**RFI**

RFI #: 31  
 Date: 1/10/2012  
 Job: EB-02 Keller Springs Lofts  
 Phone: 877-777-5115

CC: Jordan & Skala Engineers, Inc. (Dallas)  
 Subject: Detail for 12 sleeve penetration and elevation

Drawing: P3.0D  
 Cost Impact: None  
 Spec Section:  
 Schedule Impact: None

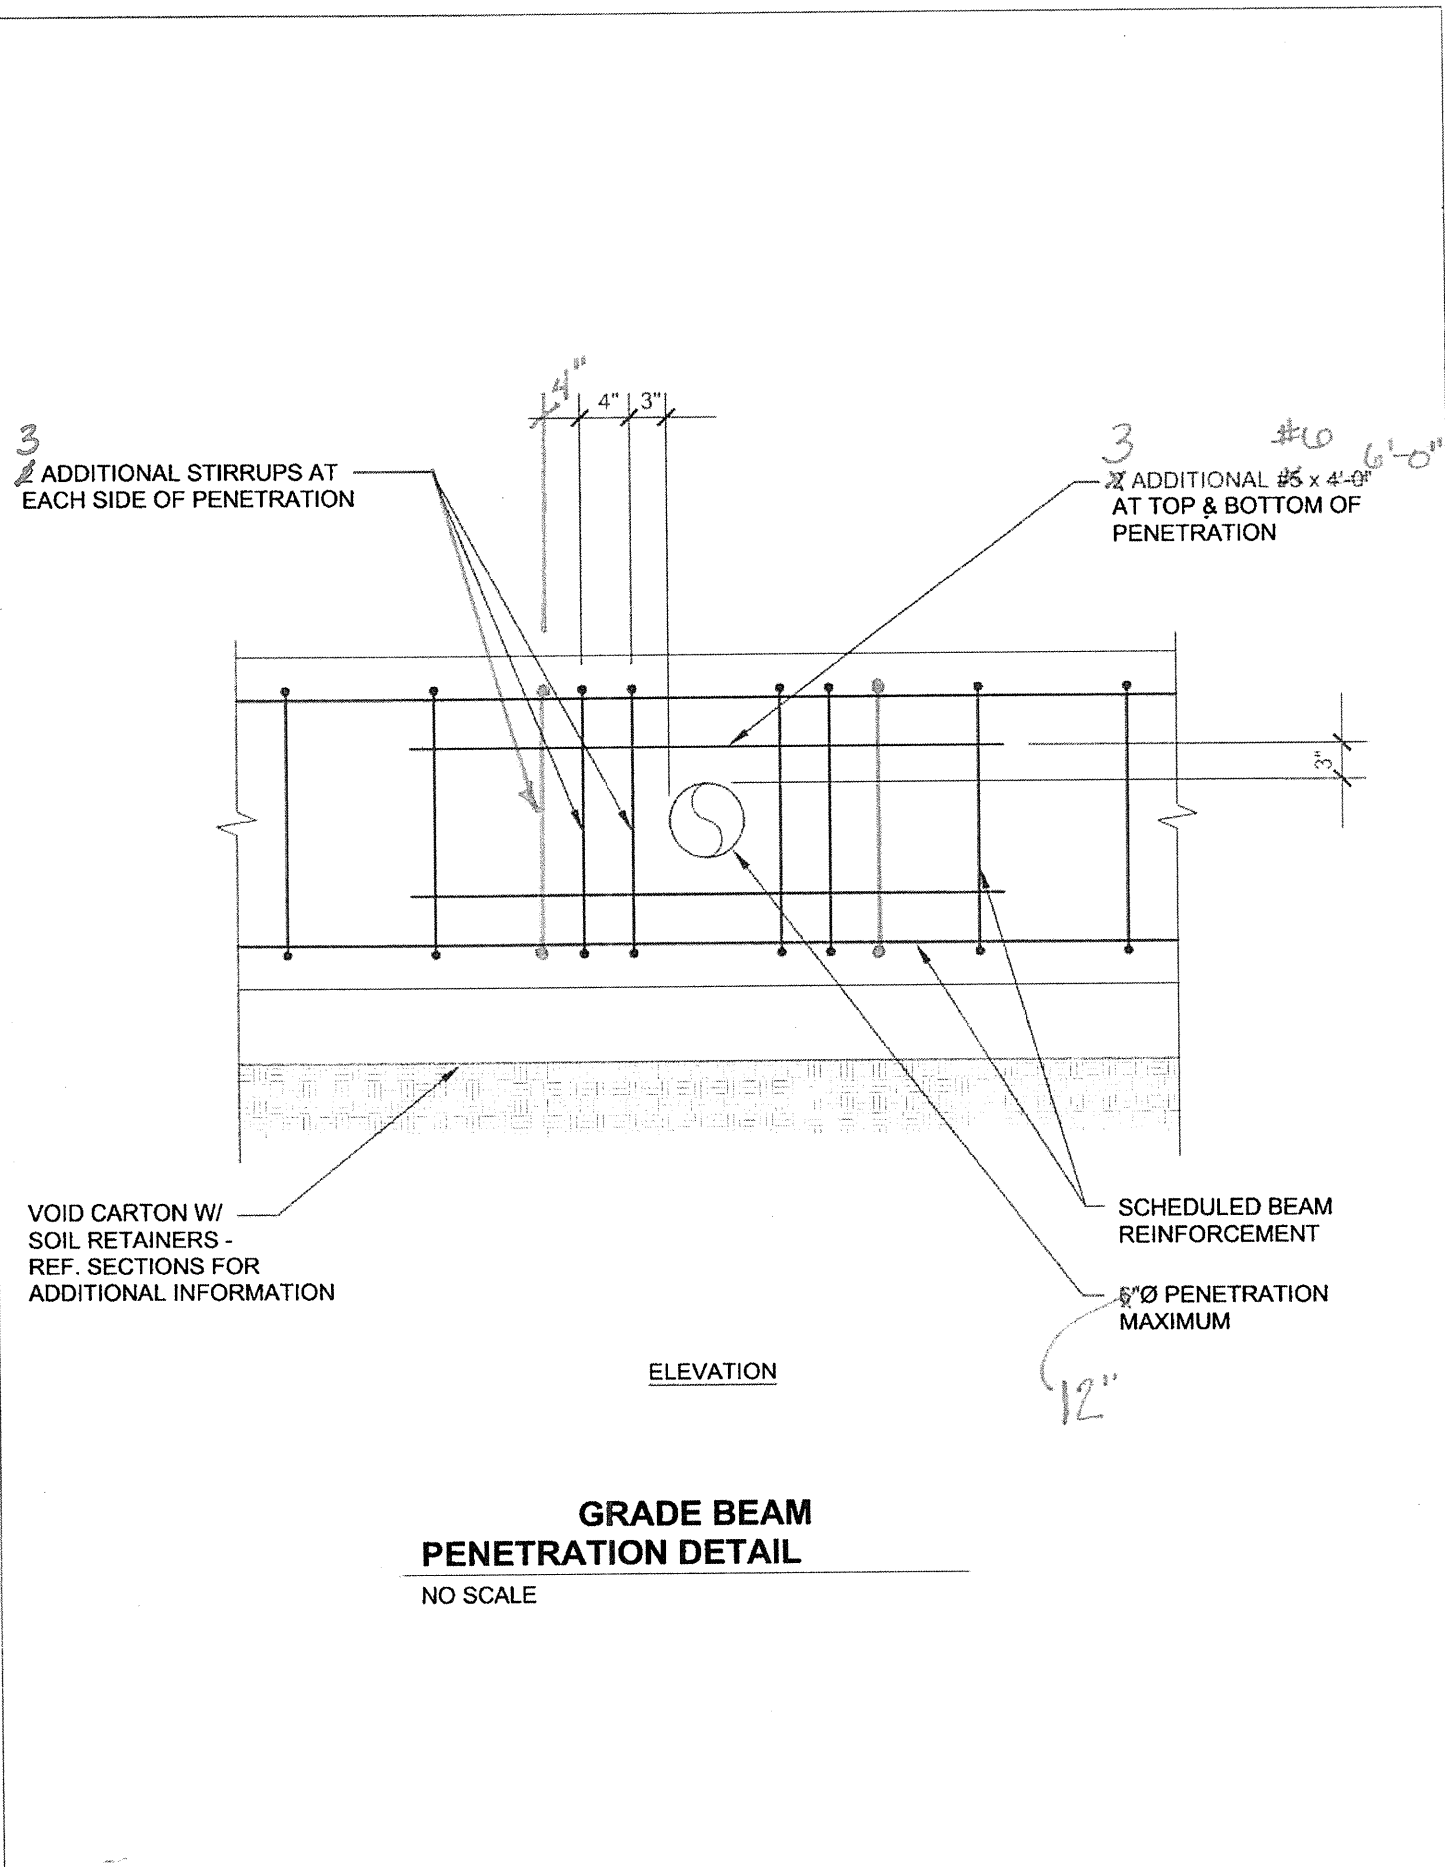
**Request:**  
 Trent we need a detail for (2) 12" drain sleeves that penetrate the southern beam wall of the garage Ref P 3.0D attached.  
 The structural engineer wants sleeves in the middle third of the beam wall. Top of Beam Wall = 639'-7 1/4" and beam is 4' deep 637'-7 1/4". Middle of the beam = 637'-7 1/4" - 6" (1/2 x 12") = 637'-1 1/4". So the bottom of the two 12" sleeves should be at 637'-1 1/4" or 637.10. This should give us plenty of fall as the original flow line of the 15" on C8 was 636.22 just inside the building. Ref C8. Can both PPO and Jordan & Skala concur and reflect it on their plans and detail?

**Response:**  
 Plumbing plans have been updated to reflect to elevation of 637.10 at the garage beam wall.
